901 Harrison

Design Review Board

MACFARLANE PARTNERS & ANKROM MOISAN ARCHITECTS, INC.
DPD #3016723 / **NOVEMBER 05, 2014**

2. Street Level Design.

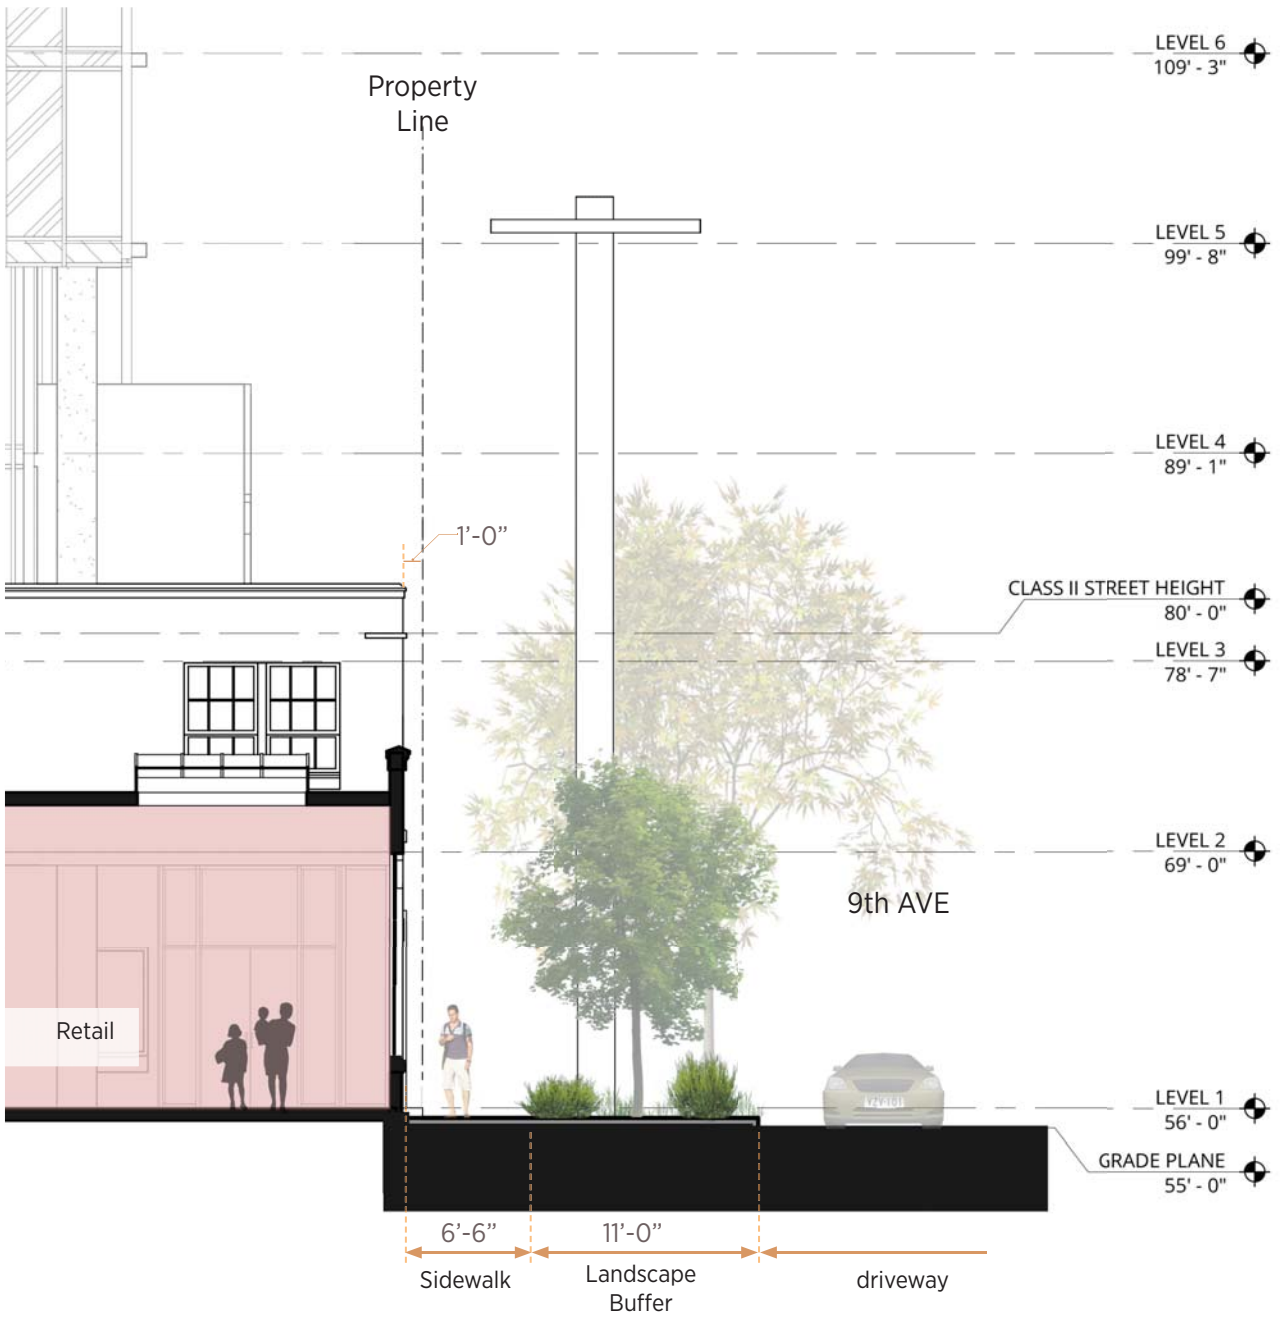
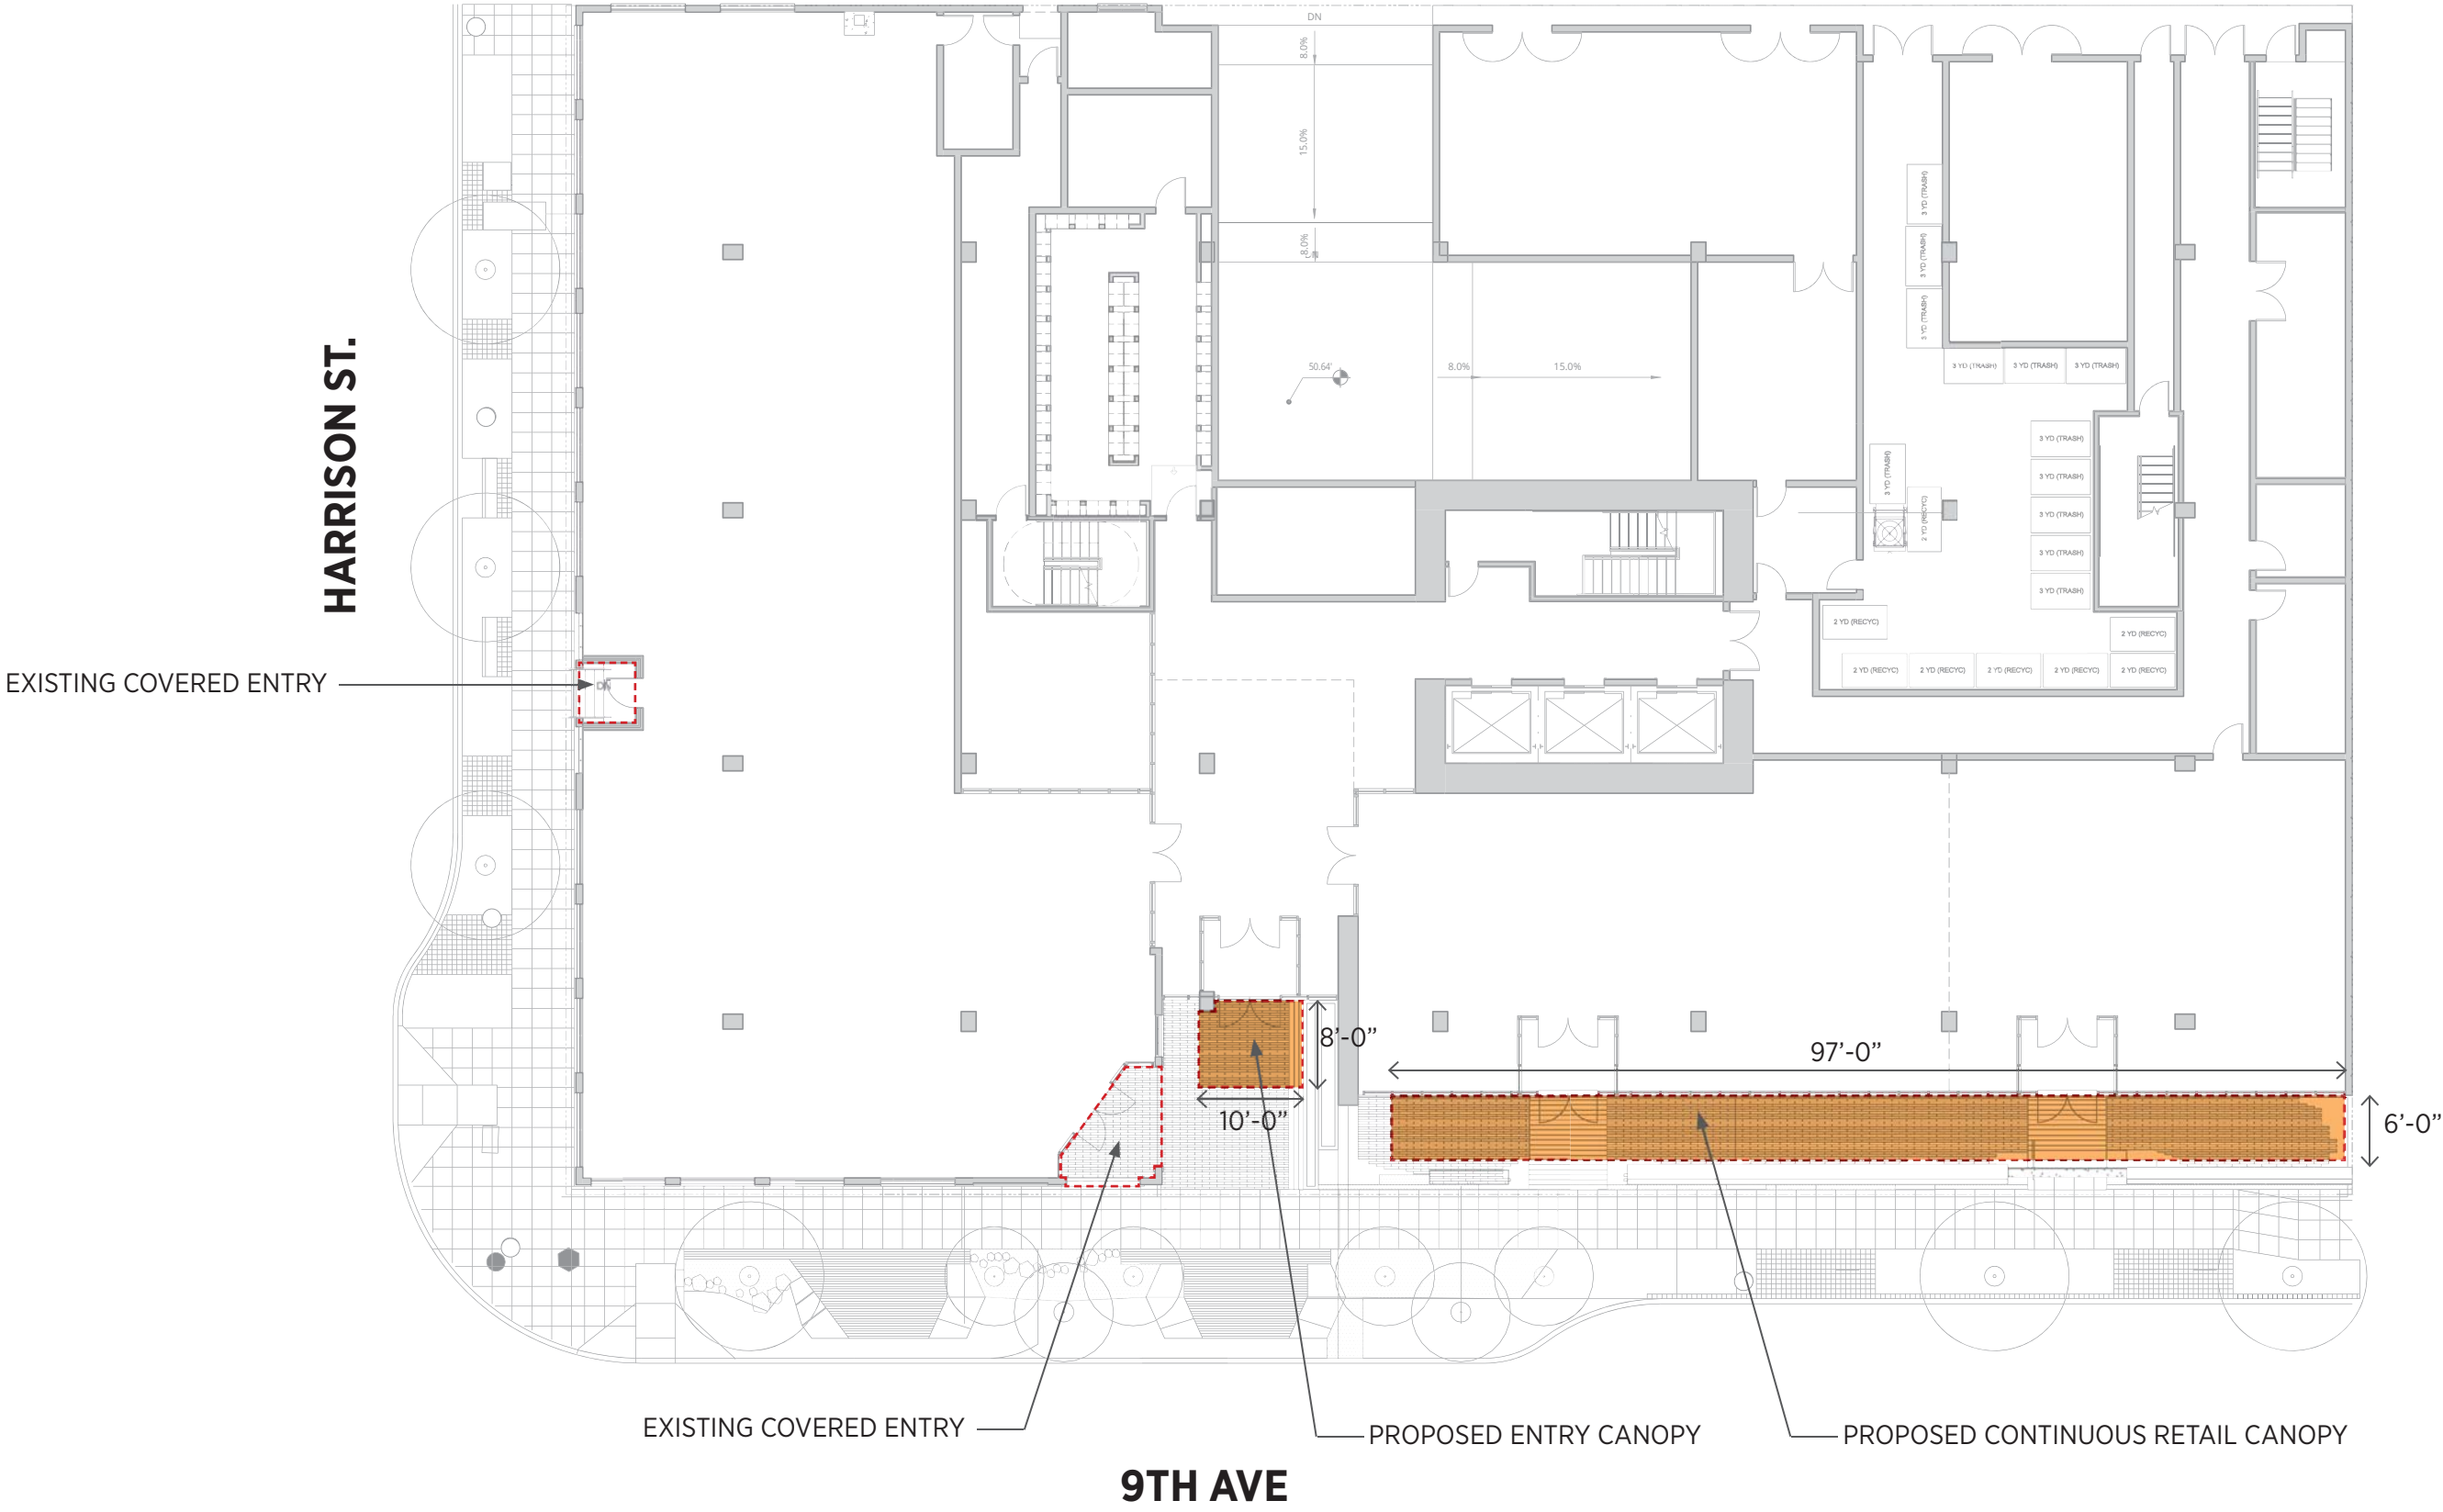
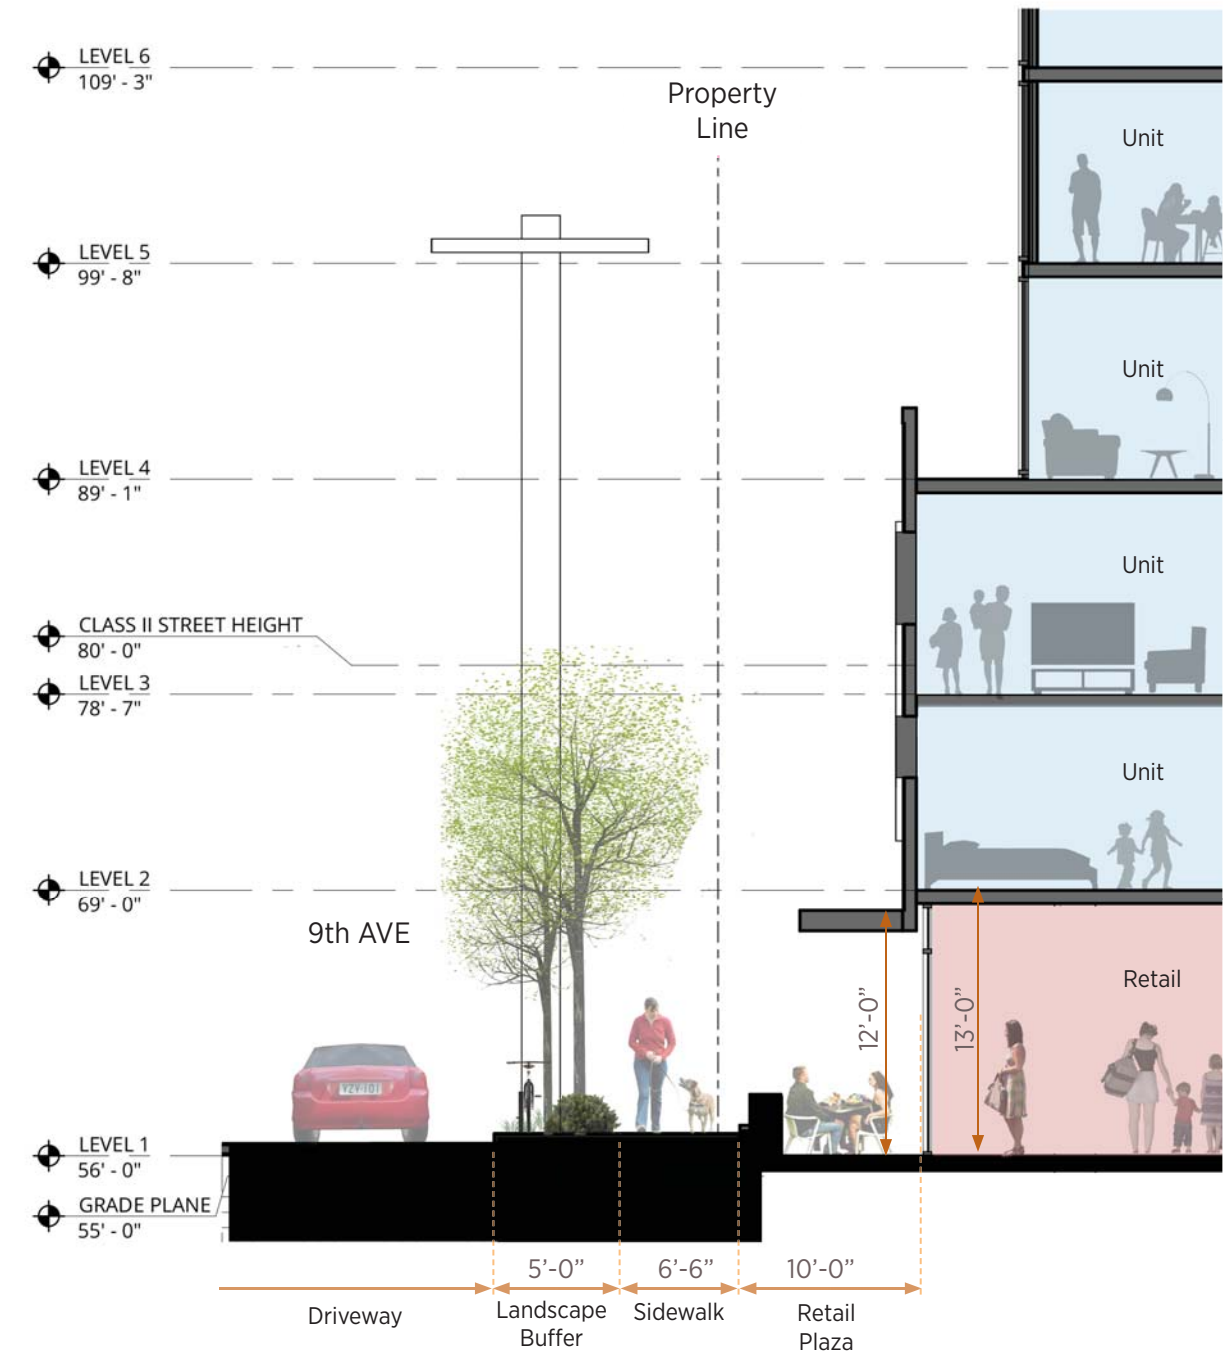
- 2a** “...strongly consider placing retail on 9th Ave N,” (CS2.B.2, PL2.I)
- 2b** “.....respond to the developing context at the intersection and the Heart Location designation of Harrison St....” (CS2.A.2, CS2.II.ii, DC2.A)
- 2c** “The Board supported the proposed curb bulb and street furniture to enhance the pedestrian experience.” (PL1.III)
- 2d** “The Board supported varying the design of the overhead weather protection at the street frontage...” (PL2.C)
- 2e** “The Board also supported the conceptual sketches indicating the design intent for the street level entries, street facing facades, landscaping, and hardscape.” (PL3.A.1 and 4)
- 2f** “The 9th Ave N. curb bulb and street level treatment should be designed to respond to the intended bicycle route along 9th Ave N. and the neighborhood streetscape plan for 9th Ave N.”

- Expanded curb bulb as **pocket park** engaging the public sidewalk and lobby/retail spaces
- Trees clustered to create a **garden** setting
- Fixed elements provide artistic **seating** opportunities

- Paving accents create area rugs for **gathering** spaces and separation of uses
- **Bike parking** distributed along length street relating to retail spaces

- Sidewalk and retail space along 9th separated by an **urban fissure** concept – accessible in places and visible along length: linear curbs, narrow planting slots, seat walls, and lean rails
